DEVELOPMENT REVIEW BOARD
SUPPLEMENTAL SUBMITTAL

PROJECT NO. PR-2021-006070

Re: Westpointe40 North Site Plan DRB Comment Responses (PR-2021-006070)

This memo outlines the responses and changes made to the site plan for the proposed 150K spec industrial building at Westpointe40 based on the comments received and reviewed at the December 15, 2021 DRB meeting.

TITAN 150K SPEC BUILDING ALBUQUERQUE, NM	DRAWN BY pm
	CONCEPTUAL MASTER UTILITY PLAN	DATE 12-22-21
	5571 MIDWAY PARK PL. NE ALBUQUERQUE, NEW MEXICO 87109 (505) 858-3100 www.tierrawestllc.com	DRAWING 2020088-150K-MU.DWG
RONALD R. BOHANNAN P.E. #7868		SHEET # MU-1
		JOB # 2020088

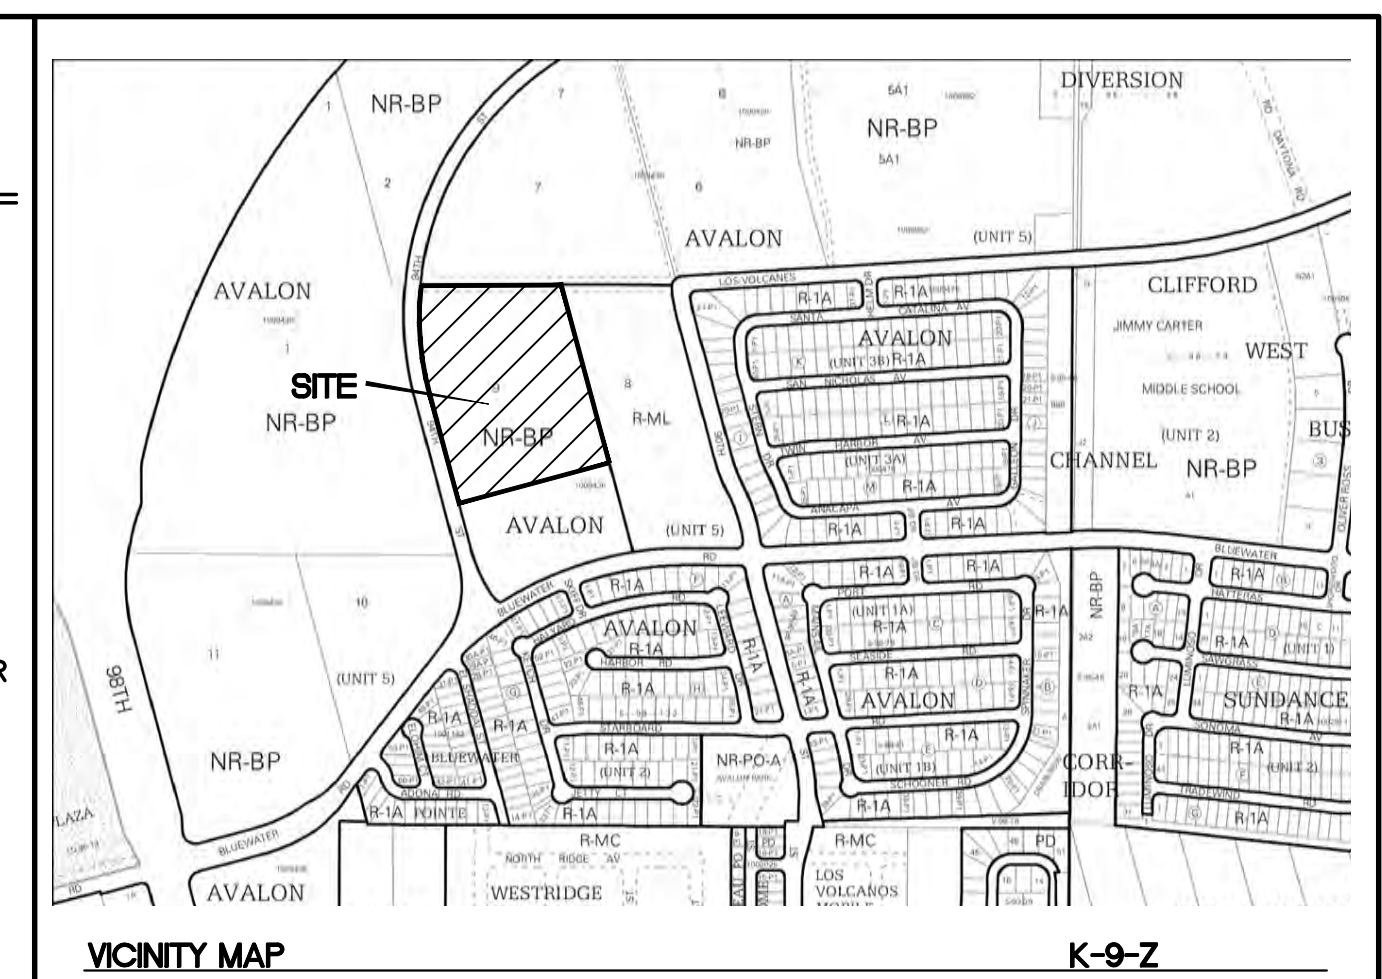
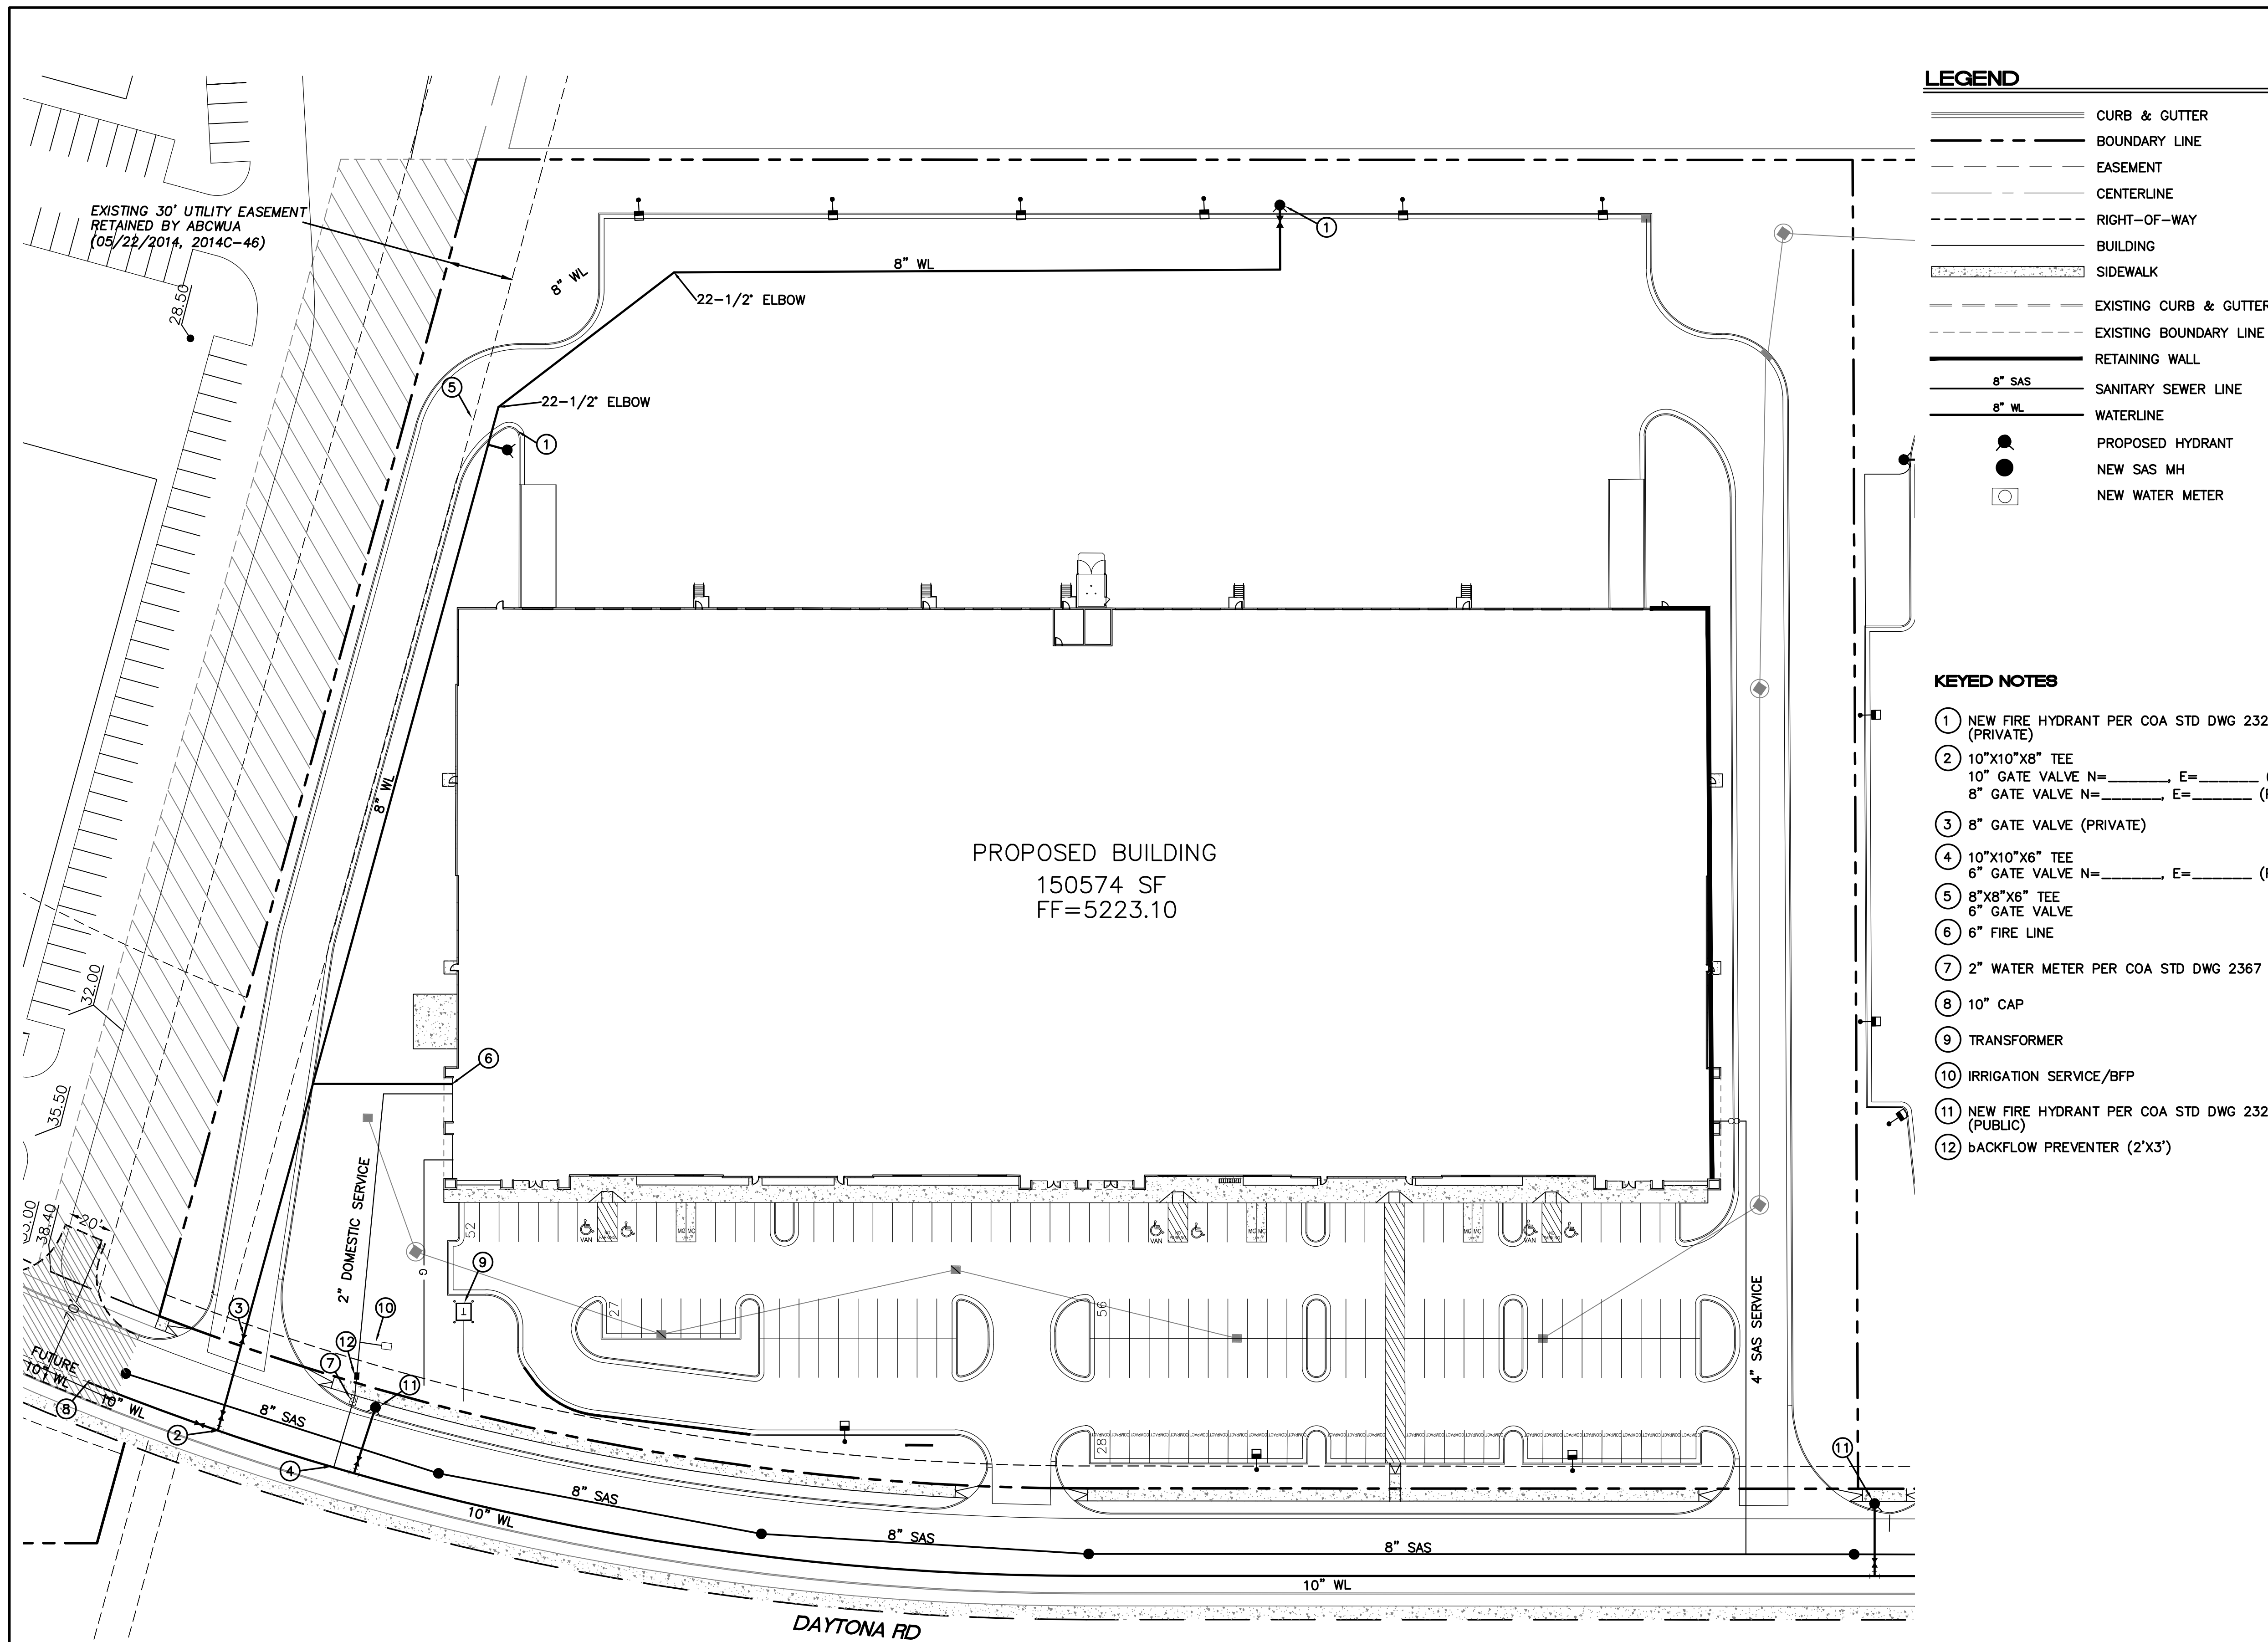
1. Availability Statement #210916R has been issued and provides the criteria for service. Extensions are required.
 - *Understood. An infrastructure list is included with the site plan.*
2. This project is within the adopted service area.
3. Pro rata is not owed for this property.
4. Utility Plan:
 - a. The backflow device should precede any other branches in the service. This should be before the separate to the irrigation yard lines.
 - *An updated utility plan has been provided with the supplemental submittal showing the backflow device before the split to the irrigation line.*

WESTPOINTE 40 SPEC#1 ALBUQUERQUE, NM	DRAWN BY AS
	FIRE ONE PLAN AVALON SUBDIVISION UNIT 5	DATE 9-8-21
9-8-21 RONALD R. BOHANNAN P.E. #7868	TIERRA WEST, LLC 5571 MIDWAY PARK PL. NE ALBUQUERQUE, NEW MEXICO 87109 (505) 858-3100 www.tierrawestllc.com	DRAWING 2021066-FO
		SHEET # FO-1
		JOB # 2021066

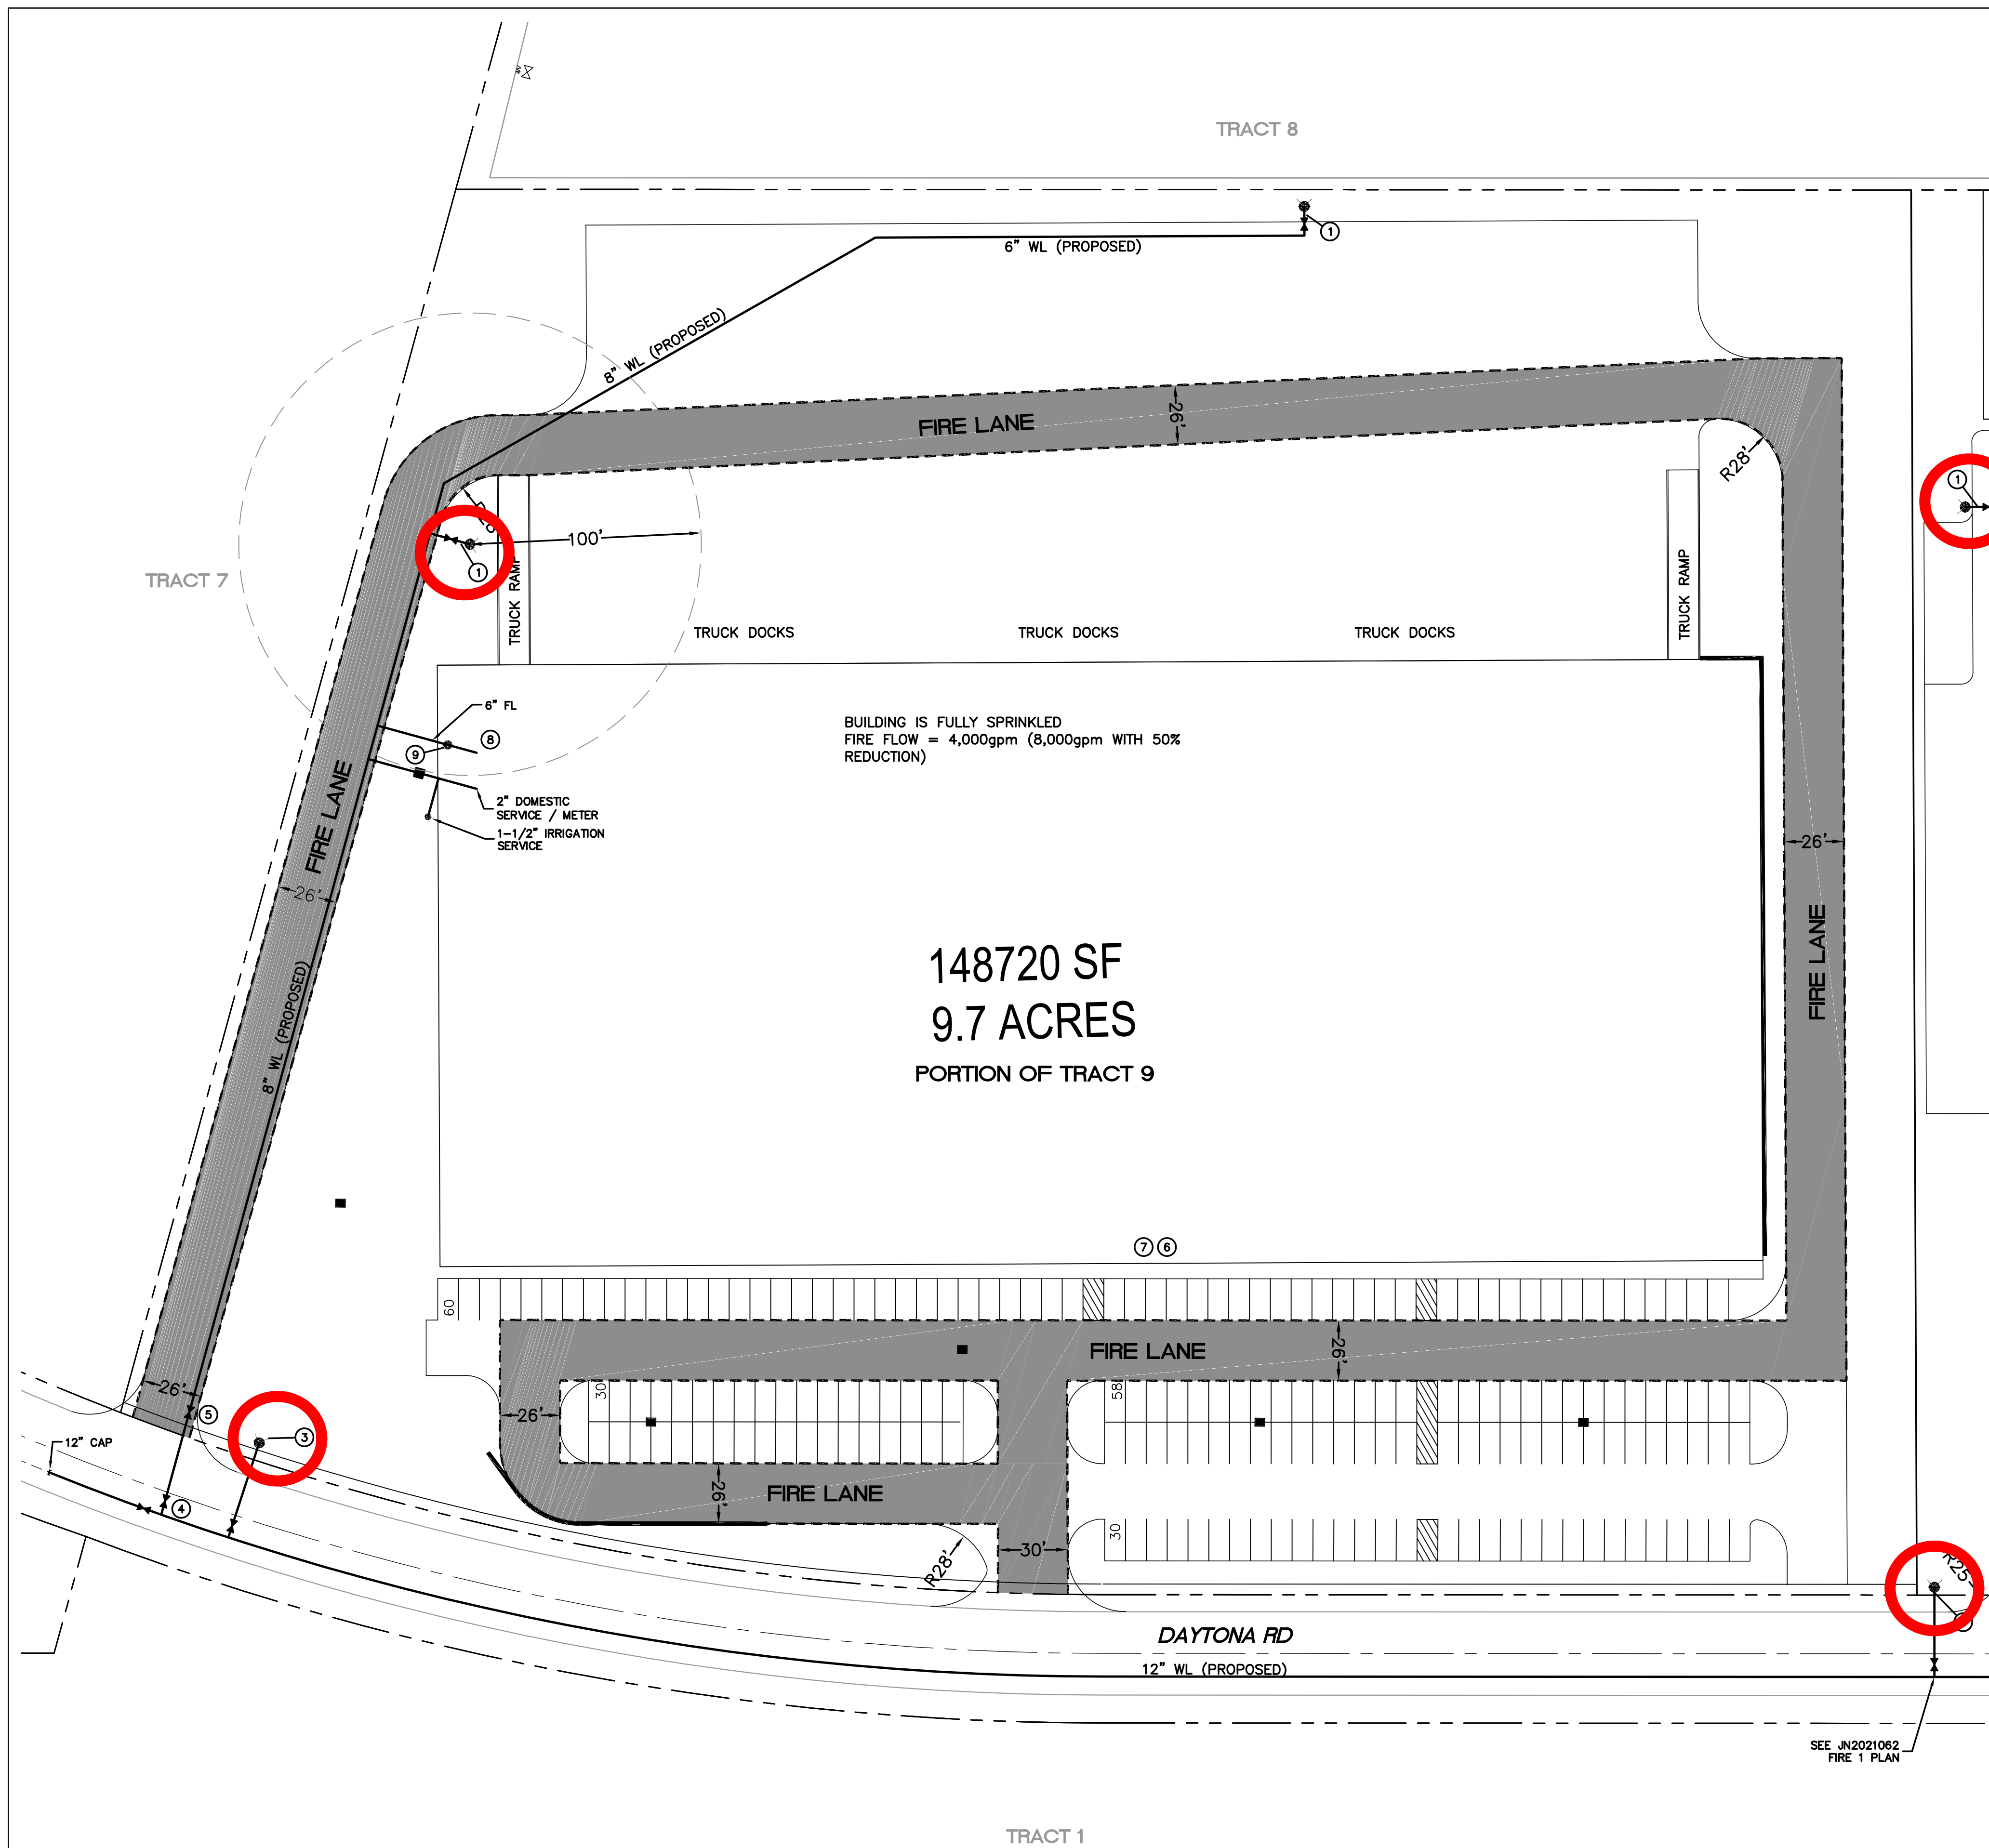
4. Obtain Fire-1 plan for the submittal set.
 - *The approved Fire 1 plan has been added to the attached plan set.*
